# Access Compliance Report

## Public Rights-of-Way

### (Curb Ramps)

Intersection ID: 49926	Main Street: CAMPBELL_HALL_CT	Cross Street: WOBURN_RD	Location: SE
ADA ID: ADED2299AF0E	Ramp Type: Perp	Initial Pass/Fail: Fail	Overall Compliance: No
Severity Score: 12.5			
Codes/Mitigation Info/Possible Solution		Field Measurements/Component Compliance

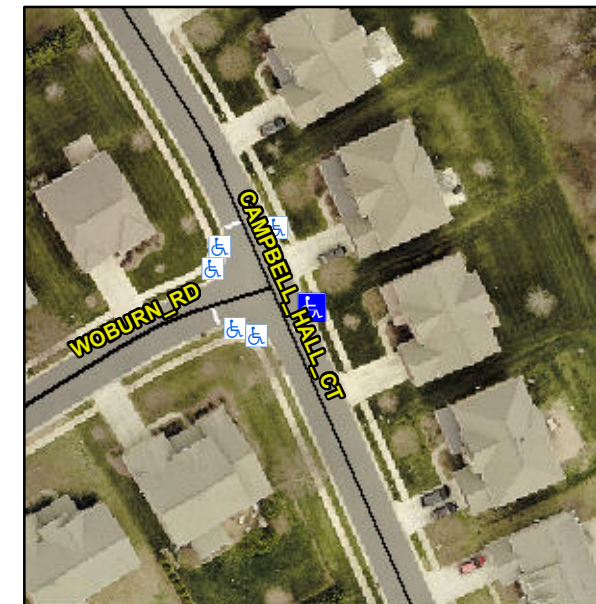
**Remove & Replace Entire Ramp.**

**Not Found, R304.2.2**

Compliance	Description	Data	Compliance	Description	Data
N/A	Ramp Length (in)	47.0	No	Ramp Slope (%)	9.1
Yes	Ramp Width (in)	48.0	Yes	Ramp XSlope (%)	0.5
N/A	Flare Type LT	N/A	N/A	Flare Type RT	N/A
N/A	Flare Slope LT (%)	N/A	N/A	Flare Slope RT (%)	N/A
N/A	Flare Traversable LT?	N/A	N/A	Flare Traversable RT?	N/A
N/A	Landing Length (in)	N/A	N/A	DWS Provided?	N/A
N/A	Landing Width (in)	N/A	N/A	DWS Contrast?	N/A
N/A	Landing Slope (%)	N/A	N/A	DWS Length (in)	N/A
N/A	Landing X Slope (%)	N/A	N/A	DWS Full Width?	N/A
N/A	Landing Curb? (Y/N)	N/A	N/A	DWS Offset (in)	N/A
N/A	Shared Landing?	N/A			
N/A	Gutter Ponding?	N/A	N/A	Gutter Slope (%)	N/A
N/A	Gutter Lip Ht (in)	N/A	N/A	Gutter X Slope (%)	N/A
N/A	Painted X Walk1?	No	N/A	Painted X Walk2?	N/A
	X Walk 1 Direction	To SW		X Walk 2 Direction	N/A
N/A	X Walk 1 Width (in)	N/A	N/A	X Walk 2 Width (in)	N/A
	X Walk 1 Slope (%)	3.3		X Walk 2 Slope (%)	N/A
	X Walk 1 X Slope (%)	1.3		X Walk 2 X Slope (%)	N/A
